**North State Water Alliance (NSWA) Comments on
Cal WaterFix and RDEIR/SDEIS
Exhibits A-D
October 30, 2015**

**List of Commenting Parties
Cal WaterFix and RDEIR/SDEIS
October 30, 2015**

Report on Review of Bay Delta Conservation Program Modeling

Figure 1. Projected Inflow to Trinity, Shasta, Oroville, and Folsom Reservoirs – NAA, NAA-ELT and NAA-LLT

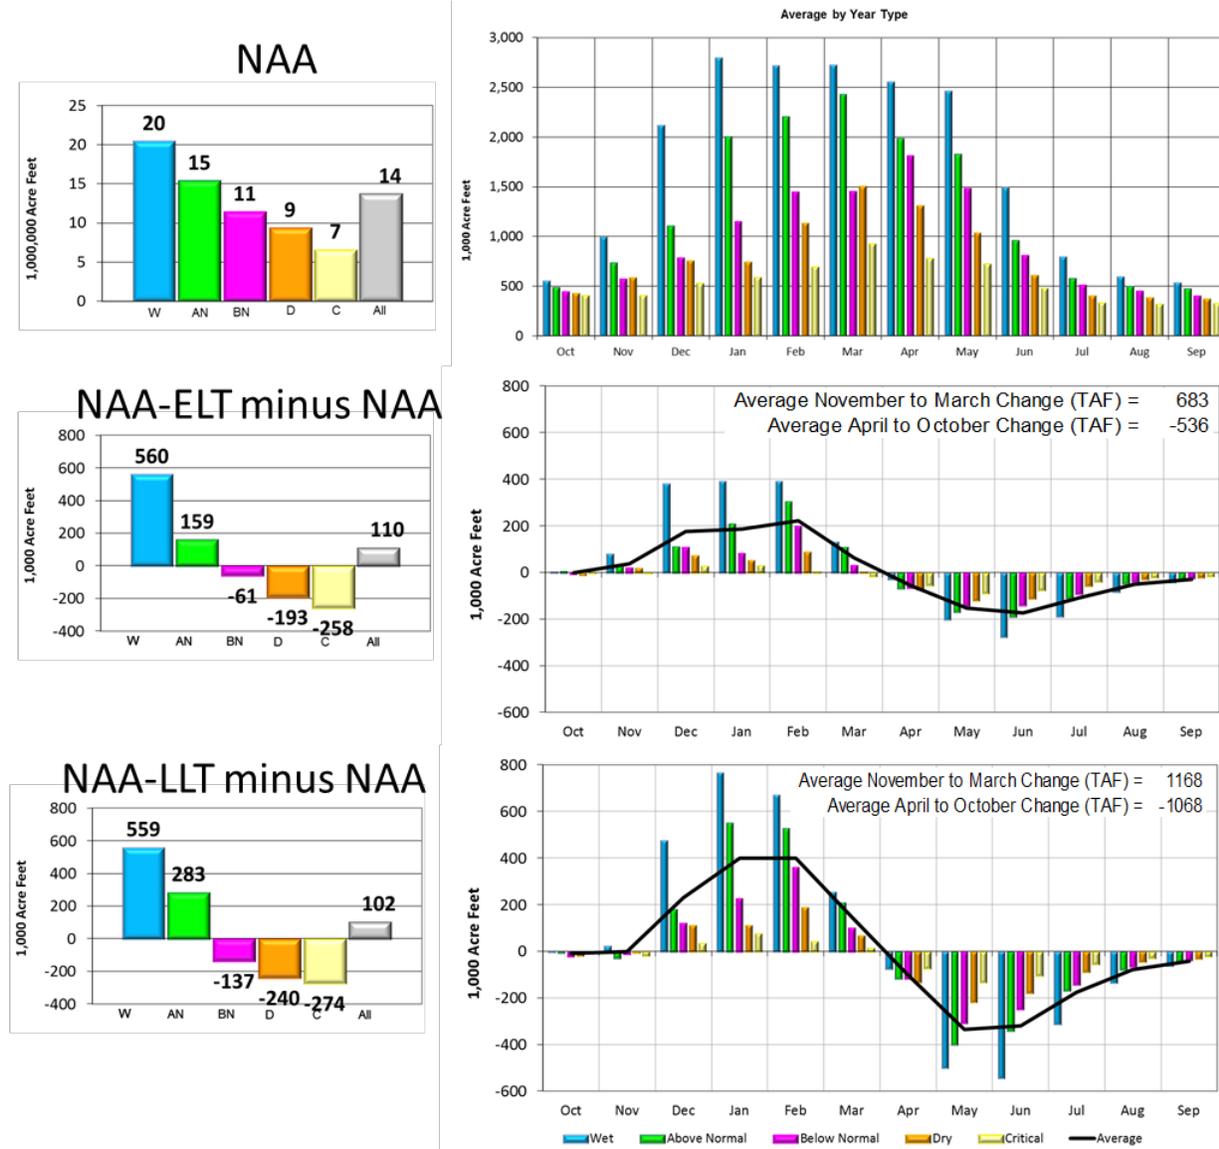
The significance of changed hydrology between the three without project baselines is illustrated in Figure 1 below. The figure illustrates the projected combined inflow of Trinity, Shasta, Oroville, and Folsom Reservoirs under the three NAA baselines. Numerous modeling projections for climate change have been developed, and in this BDCP group of Scenarios Trinity, Shasta, and Oroville inflow are projected to increase overall, but with a

In our opinion, the CalSim II depicted operations that incorporate climate change are not reasonably foreseeable and do not represent a likely future operation of the CVP/SWP. Although an argument is typically made that these study baselines will be used in a comparison analysis with Project Alternatives tiering from these baselines, we believe that the depicted operations do not represent credible CVP/SWP operations and we have no confidence in the results and they are inappropriate as the foundation of a Project Alternative. As such, although the modeling approach may provide a relative comparison between equal foundational operations, we are apprehensive to place much confidence in the computed differences shown between the NAA and Project Alternative Scenarios.

Figure 2. Projected Shasta Reservoir Carryover Storage, NAA, NAA-ELT and NAA-LLT

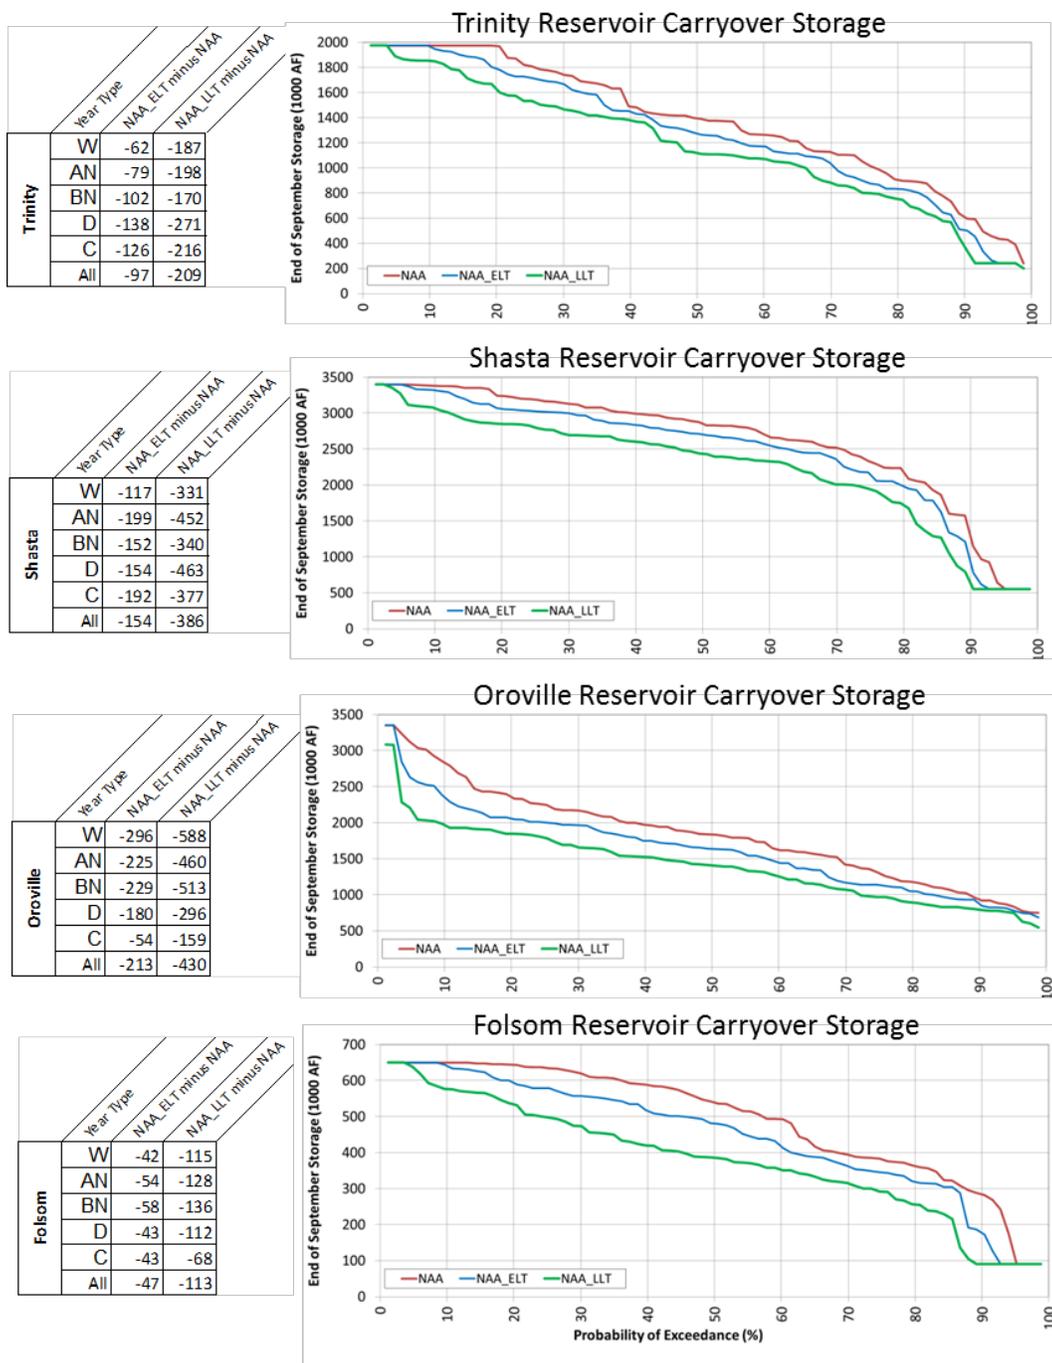
For upstream CVP and SWP reservoirs the assumed shift of inflows due to climate change (Figure 1) along with a continuing need to satisfy exports demands significantly affects carryover storage. The CVP and SWP simply cannot satisfy water demands and regulatory criteria imposed on them in the NAA-ELT and NAA-LLT modeling scenarios.

Figure 2 illustrates the typical change in carryover storage as shown for Trinity, Shasta, Oroville, and Folsom Reservoirs. The relatively high frequency (approximately 10% of time) of minimum storage occurring at CVP reservoirs illustrates our questioning of credible operations in the studies.

Figure 3. Projected Inflow to Millerton Lake –NAA, NAA-ELT and NAA-LLT

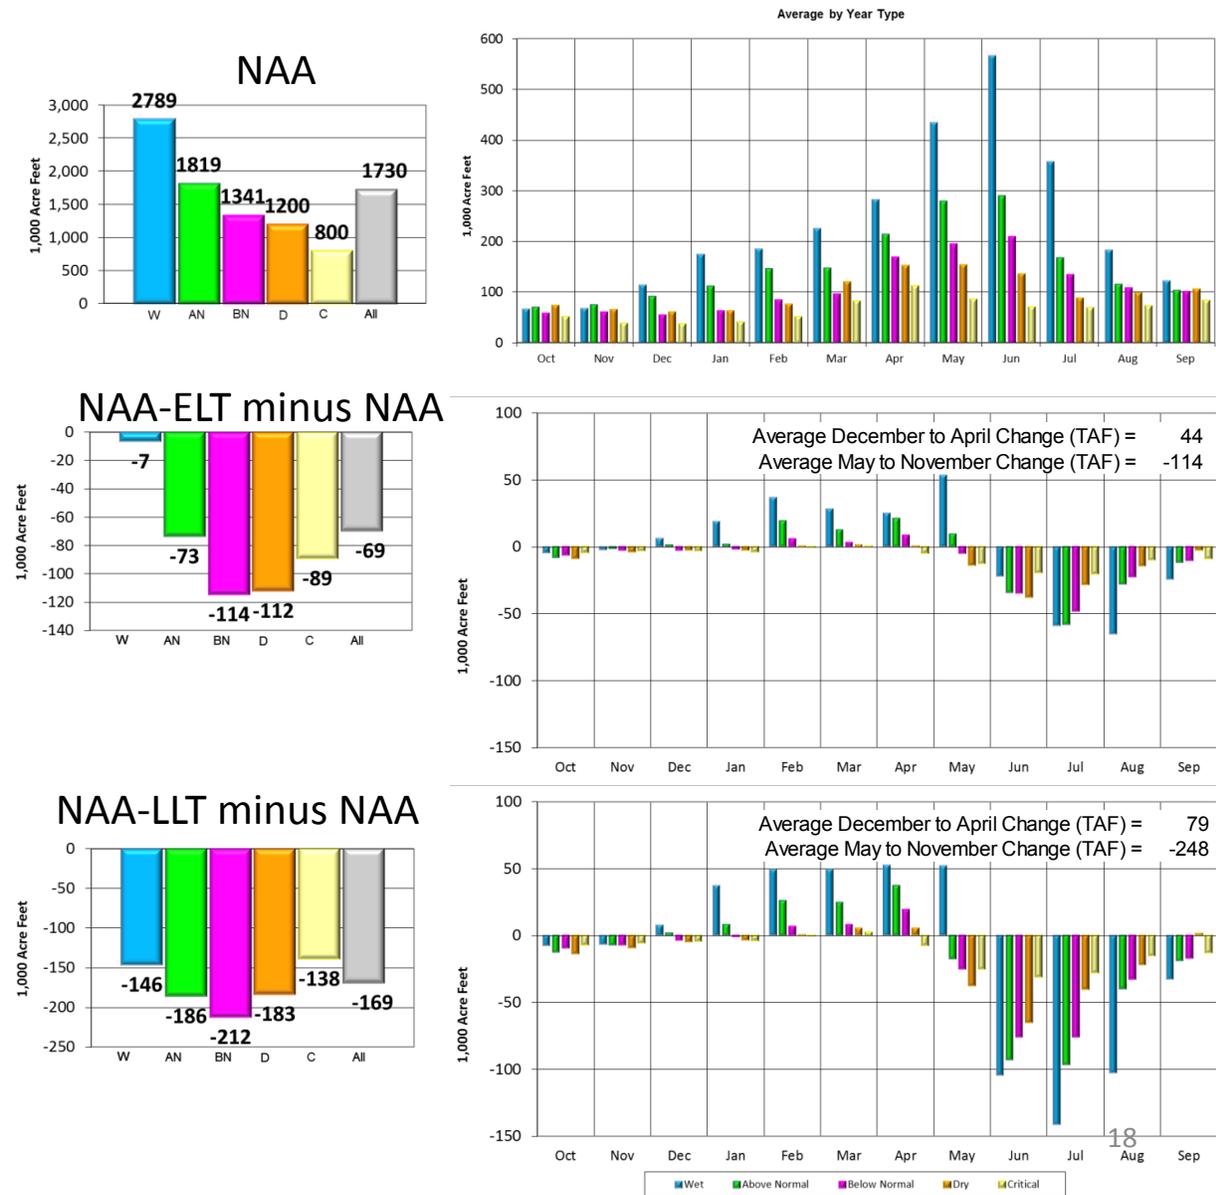
San Joaquin Valley reservoirs are depicted with an overall decrease in annual runoff with some shifting of runoff from spring to winter, but mostly just decreases in spring runoff due to a decline in snowmelt runoff during late spring⁵. Figure 3 illustrates the assumed effects of climate change upon inflow to Millerton Lake.

Inflow to Millerton Reservoir in this version of CalSim is input in three separate time series for purposes of depicting the hydrology of potential upper basin reservoirs. Climate change hydrology was inconsistently incorporated at Millerton Reservoir and misapplied to the water supply and flood control operations. The result is an unrealistic operation for river releases and canal diversions. Figure 3 illustrates the projected ELT and LLT changes in Millerton Reservoir inflow incorporated in these studies. On face value of the input data, regardless of Friant Dam river release assumptions the effect of climate change at Millerton Lake will affect water deliveries.

Figure 4. Millerton Reservoir Carryover Storage, NAA, NAA-ELT and NAA-LLT Scenarios

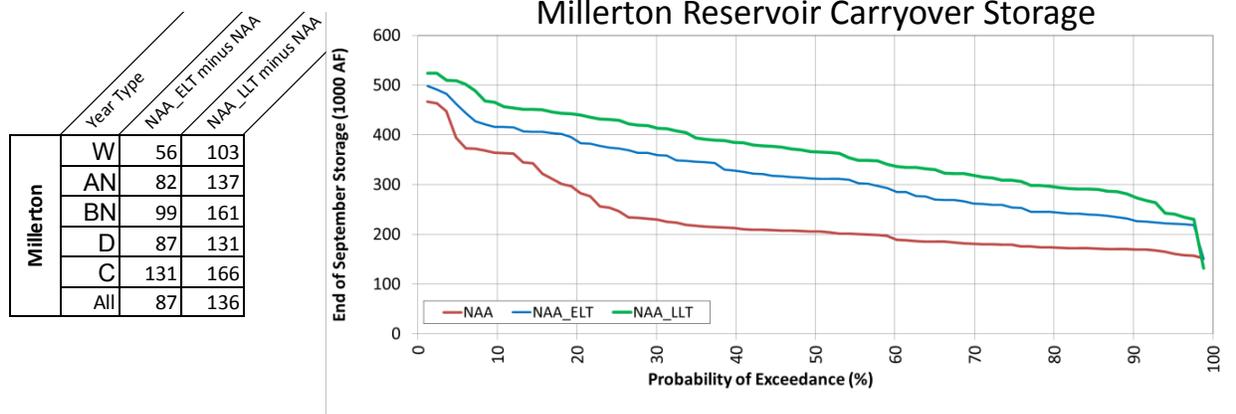
Evidence of the inconsistent inflow problem is shown in the result for the comparison of carryover storage of Millerton Reservoir under the NAA, NAA-ELT, and NAA-LLT Scenarios (Figure 4). Carryover storage is higher in the ELT and LLT Scenarios due to climate change effects to inflow incorporated in reservoir operations but not in the computation of water supply deliveries. Thus, water deliveries are suppressed and the reservoir ends the year with greater storage.

Figure 19. NDD, Bypass Requirement, Bypass Flow, and Excess Sacramento R. flow for Alt 4-ELT

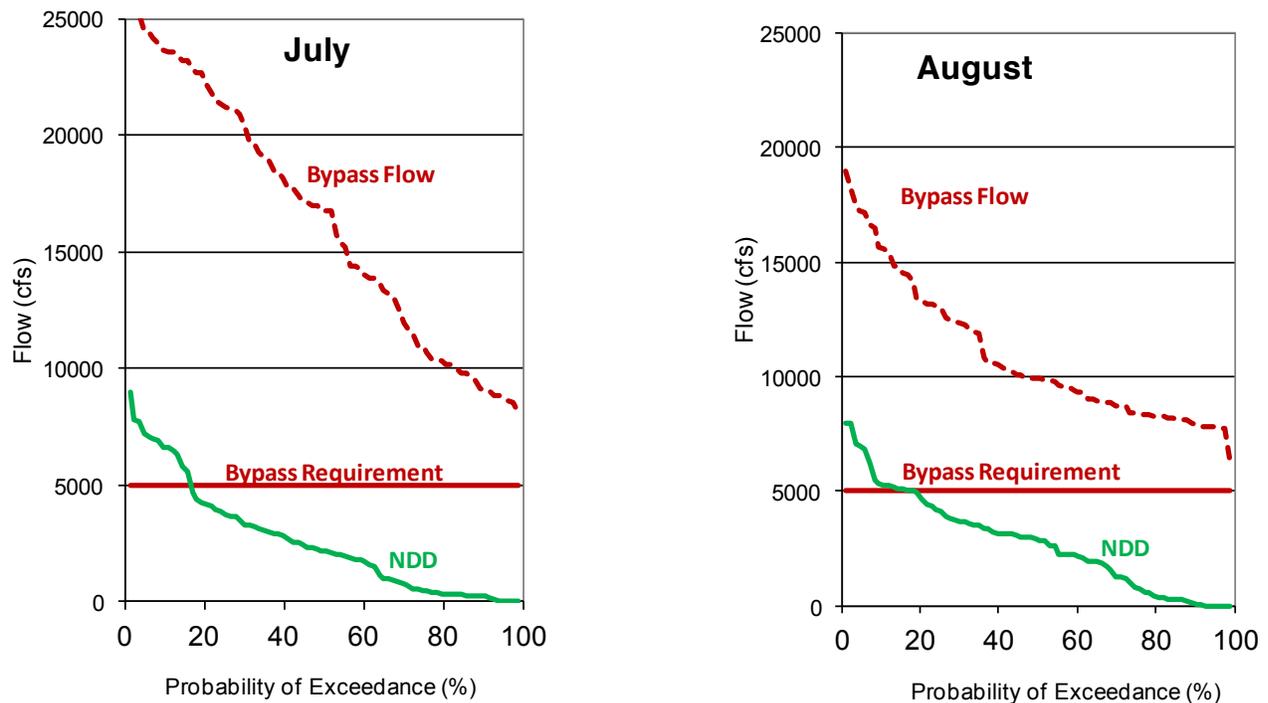
Sacramento River flow below the North Delta Diversion (NDD) must be maintained above the specified bypass flow requirement, therefore the NDD rates are limited to the Sacramento River flow above the bypass requirement. Due to an error in CalSim II that specifies an unintended additional bypass requirement, modeling performed for the BDCP EIRS often bypasses more Sacramento River flow than is specified in the BDCP project description. This error has been fixed in the most recent public releases of CalSim II, but BDCP modeling has not been updated to reflect these fixes. Figure 19 contains exceedance probability plots showing the Sacramento River required bypass, Sacramento River bypass flow, NDD, and excess Sacramento River flow to the Delta as modeling for BDCP. As can be seen in Figure 19, the bypass flow is always above the bypass requirement in July and August. The BDCP version of CalSim sets a requirement for Sacramento River inflow to the Delta needed to satisfy all Delta flow, quality, and export requirements, this requirement should be removed when modeling the NDD.

Figure 22. Alt 4-ELT North Delta Diversion Versus South Delta Diversion for July, August, and September

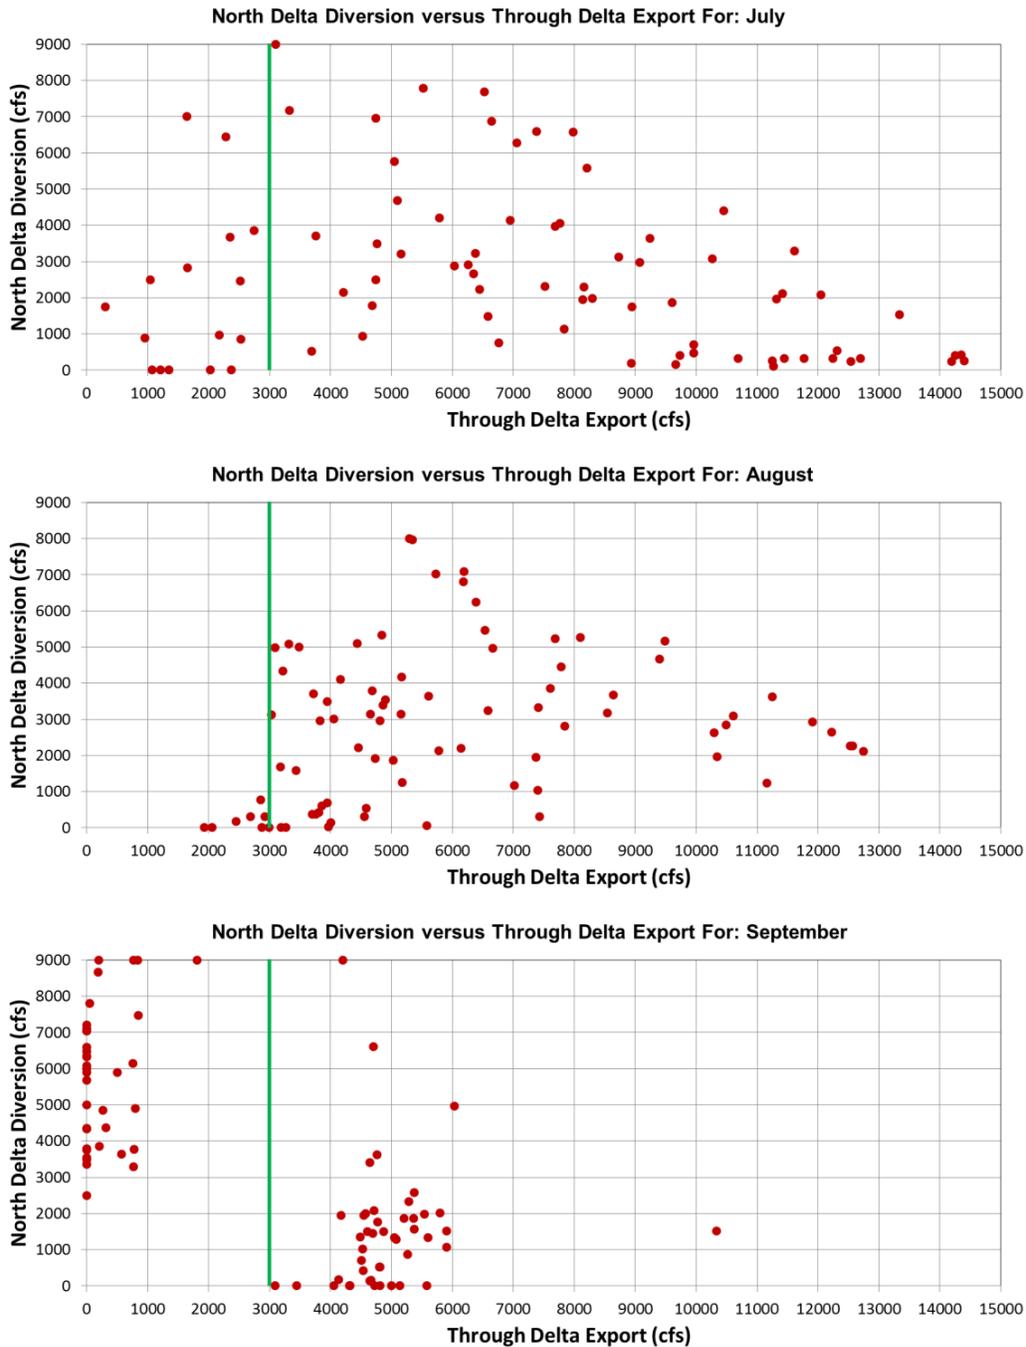
Figure 22 contains figures for July, August, and September for Alt 4-ELT that plot NDD against SDD. In the months of July to September SDD are occasionally very high, exceeding 14,000 cfs in July, with minimal NDD. This occurs due to outdated model code that imposes an instream flow requirement in Sacramento River flow below Hood in excess of the bypass criteria prescribed in the BDCP. There are numerous occurrences when bypass flows prescribed in the BDCP are exceeded and SDD are higher than expected. On the other hand, there are also many times when NDD are above minimum pumping levels and SDD are below the BDCP prescribed 3,000 cfs threshold indicated by the green line in Figure 22. For unknown reasons, the model code requiring SDD to be greater than 3,000 cfs before NDDs occur from July through September is deactivated in the BDCP modeling of this Alternative.

Figure 23. South Delta Diversion at Banks

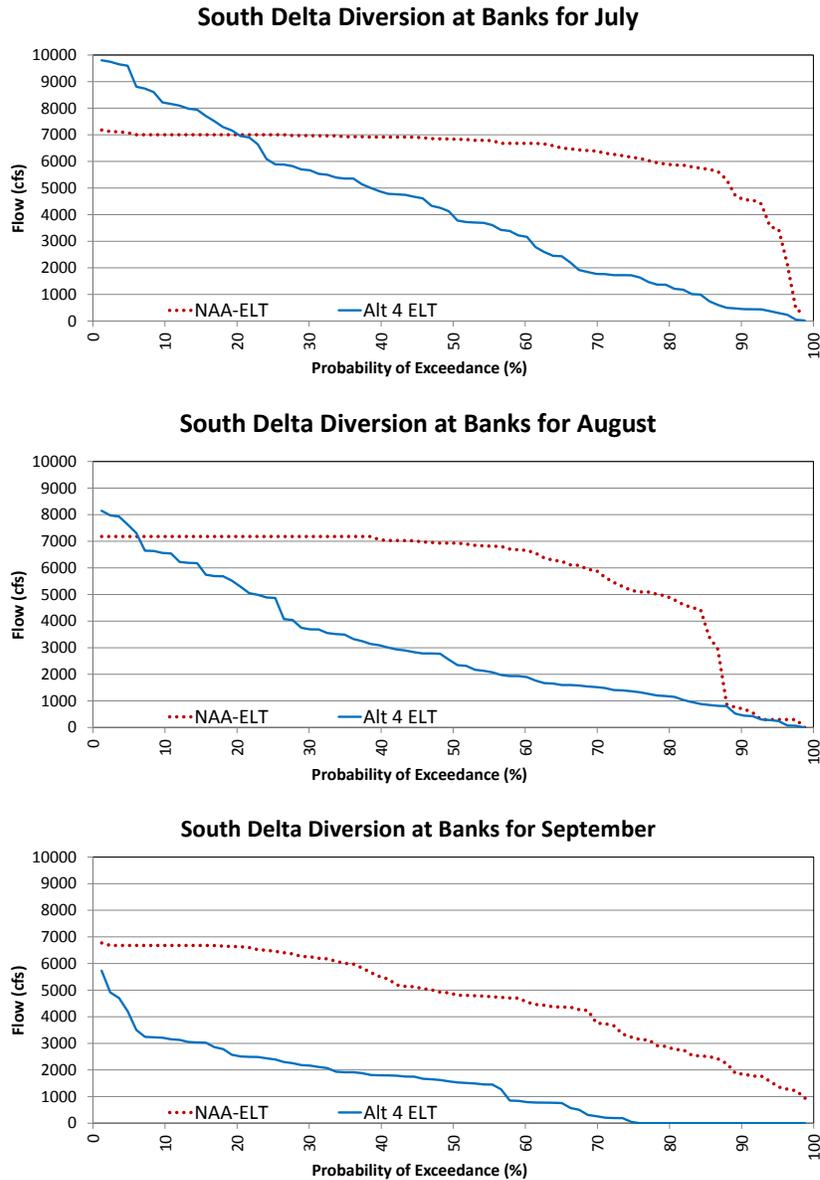
South Delta Diversion at Banks is not limited to existing permit capacity of 6,680 cfs and pumping may reach full capacity of 10,300 cfs in July, August, and September. Figure 23 contains exceedance probability charts of South Delta Diversion at Banks for July, August, and September. The chart for July shows SDD at Banks exceeding existing permit capacity 20% of years, in August this occurs in about 7% of years. There are South Delta diversions at Banks 25% of the time in September while diversions from the Sacramento River may range from 2,500 cfs to 7,500 cfs.

Figure 60. NDD, and Sacramento River Flow

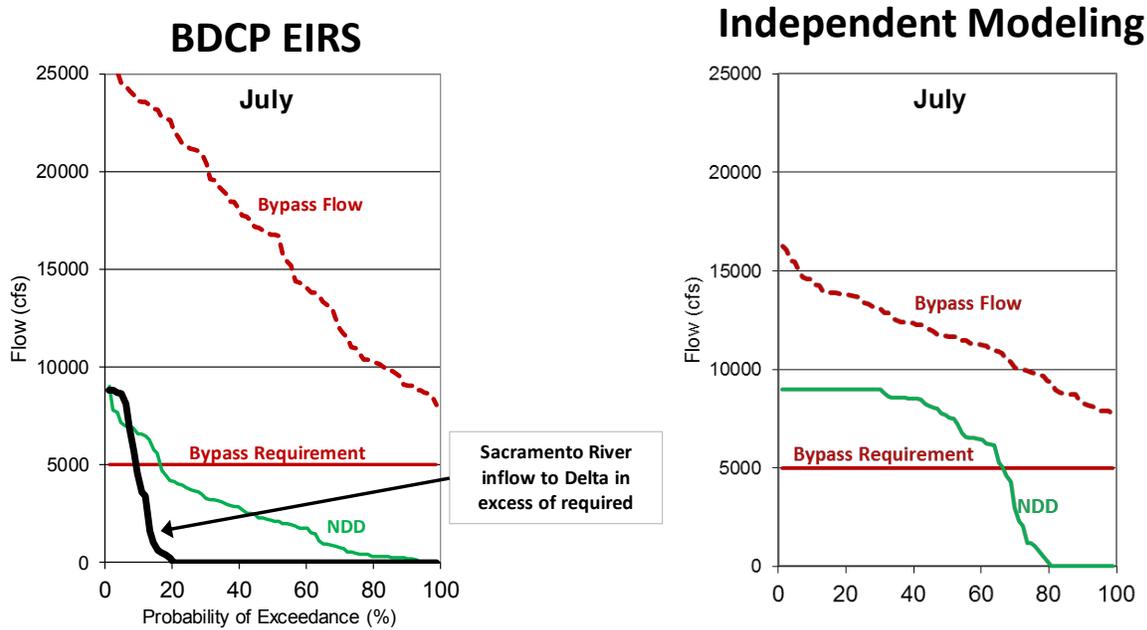
Independent modeling shows greater NDD during July and other months because the BDCP EIRS modeling includes artificially high Sacramento River bypass flow requirements. Figure 60 contains exceedance probability plots of Sacramento River required bypass, Sacramento River bypass flow, NDD, and excess Sacramento River flow to the Delta. As can be seen in Figure 60, bypass flow is always above the bypass requirement. The BDCP version of CalSim sets a requirement for Sacramento River inflow to the Delta that the independent modeling does not need in order to satisfy Delta requirements, therefore the NDD is higher in the independent modeling.
